ADDENDUM B
FINAL FIELD SAMPLING PLAN
SUPPLEMENTAL REMEDIAL INVESTIGATION
DATA GAP SAMPLING FOR
OPERABLE UNITS 1 AND 2

ALAMEDA POINT
ALAMEDA, CALIFORNIA

DS.0385.17345
August 27, 2001

Subj: ALAMEDA POINT OU-1 AND OU-2 DATA GAP SAMPLING ADDENDUM

FIGURE 6-4
ADDITIONAL SITE 11 AND 21
SAMPLING LOCATIONS
 ALAMEDA POINT
 ALAMEDA, CALIFORNIA
 AUGUST 27, 2001

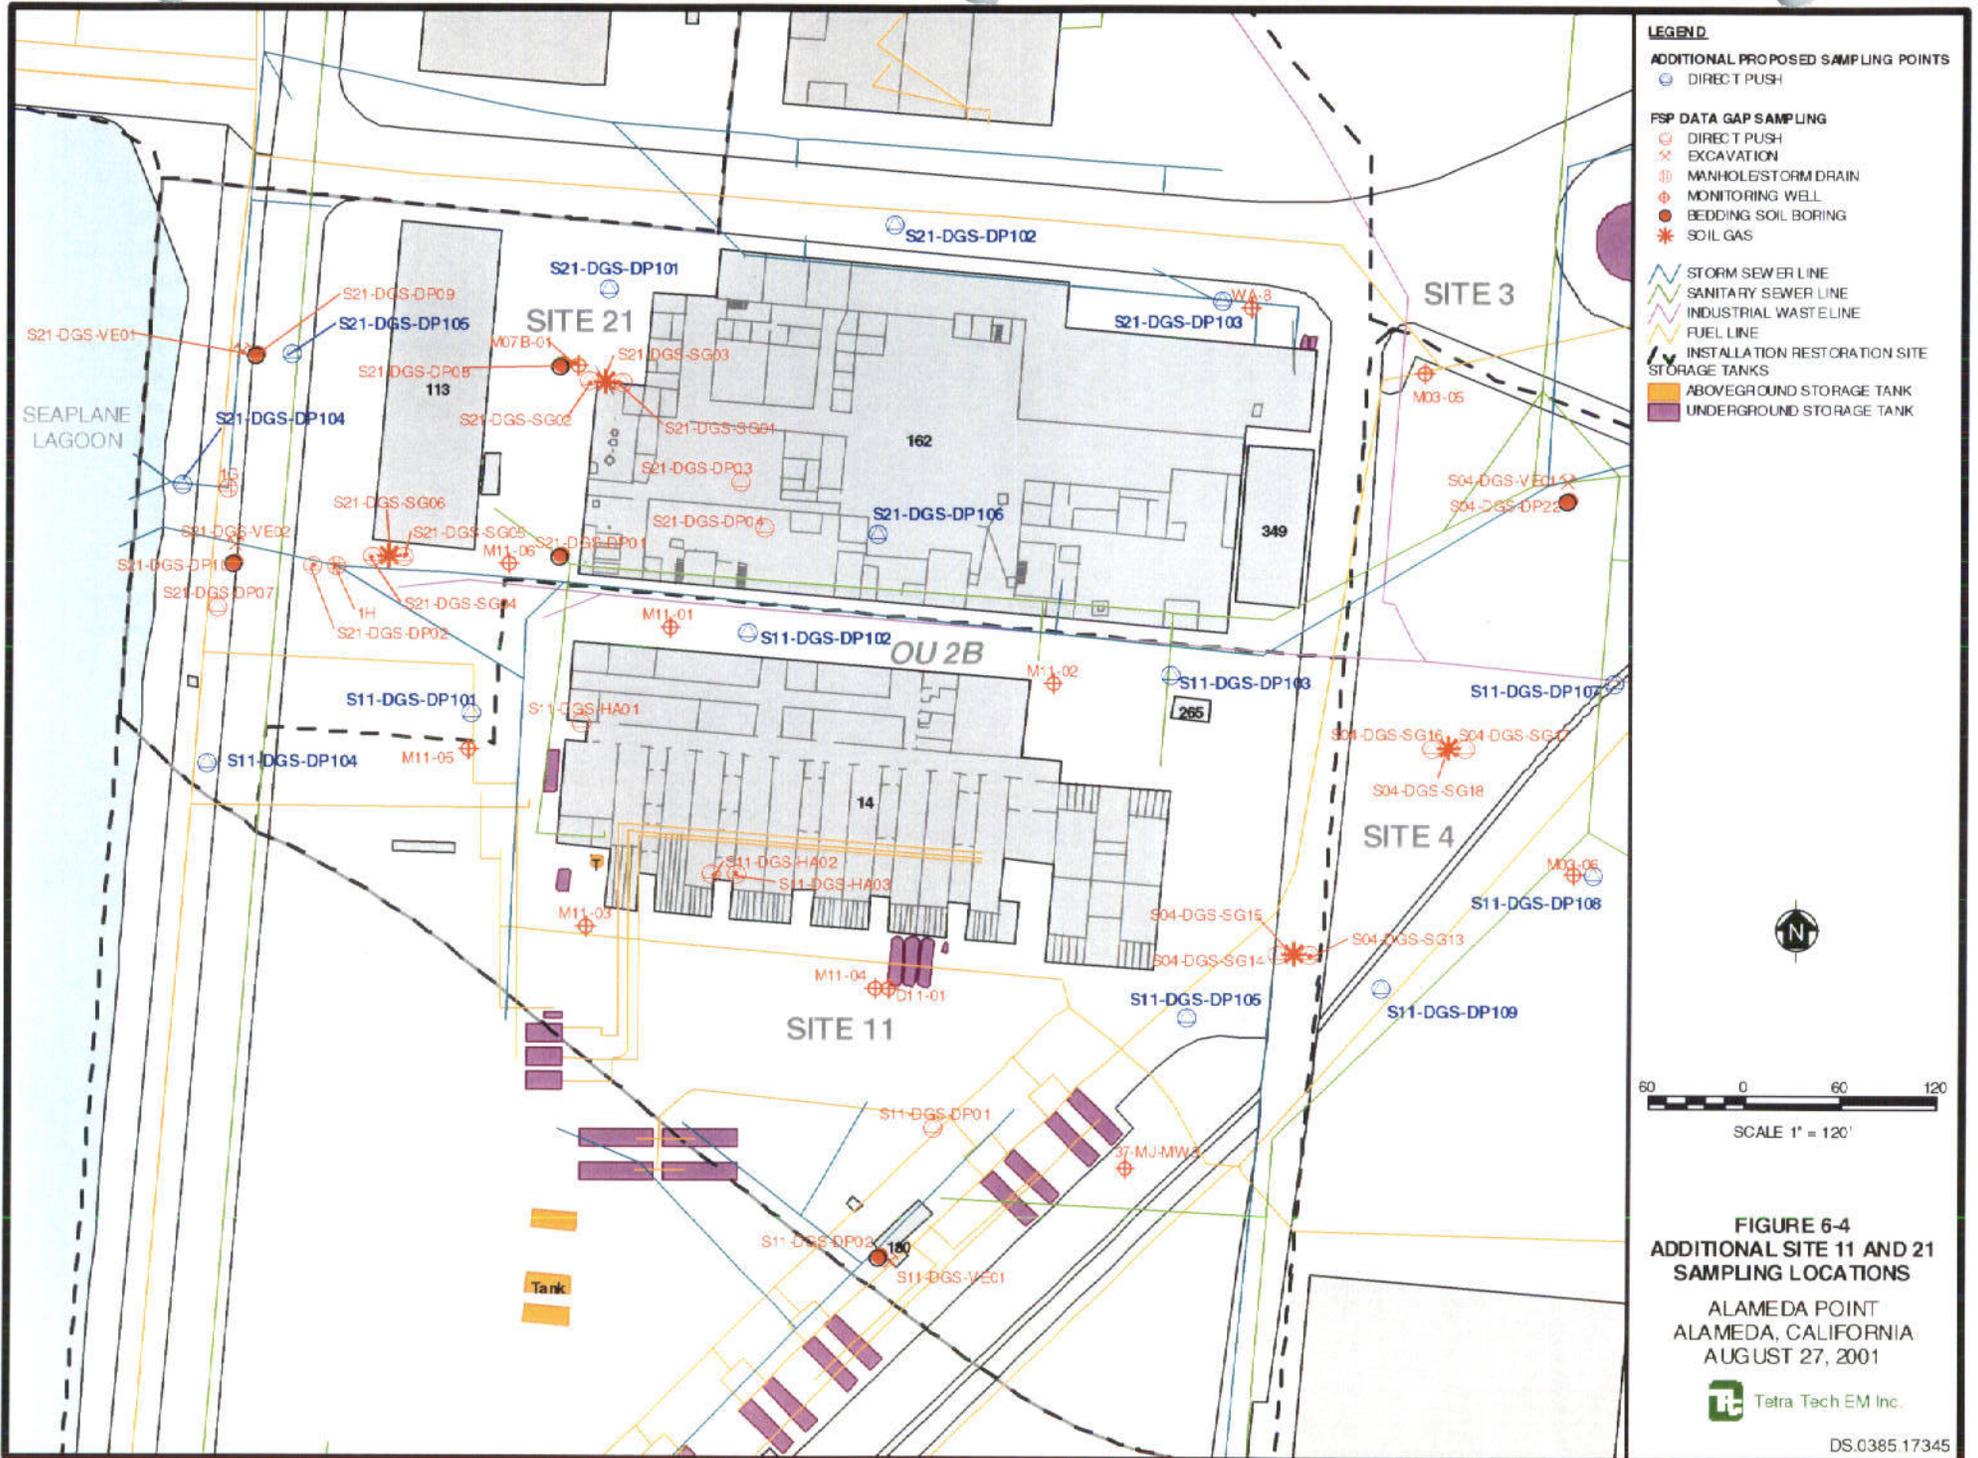
The following added text to Section 6.2.2.3 outlines the rationale, proposed sampling locations, and analyses for additional data gap sampling in the CERCLA Sites 11 and 21 area. Additional sampling locations are shown in Figure 6-4. Laboratory identification numbers, field identifications, and analyses for the 14 additional data gap sampling points are presented in added Table A-3-9 in Appendix A3 of Addendum B to the QAPP (see Attachment A, this document).

Fourteen additional direct-push groundwater sampling locations (S11-DGS-DP101 through S11-DGS-DP109 and S21-DGS-DP101 through S21-DGS-DP105) will be completed around CERCLA Sites 11 and 21 to define the edges of the VOC plume. Figure 6-4 shows these sampling locations. The actual placement of each location will be decided based on the results of current data being collected under the original FSP.
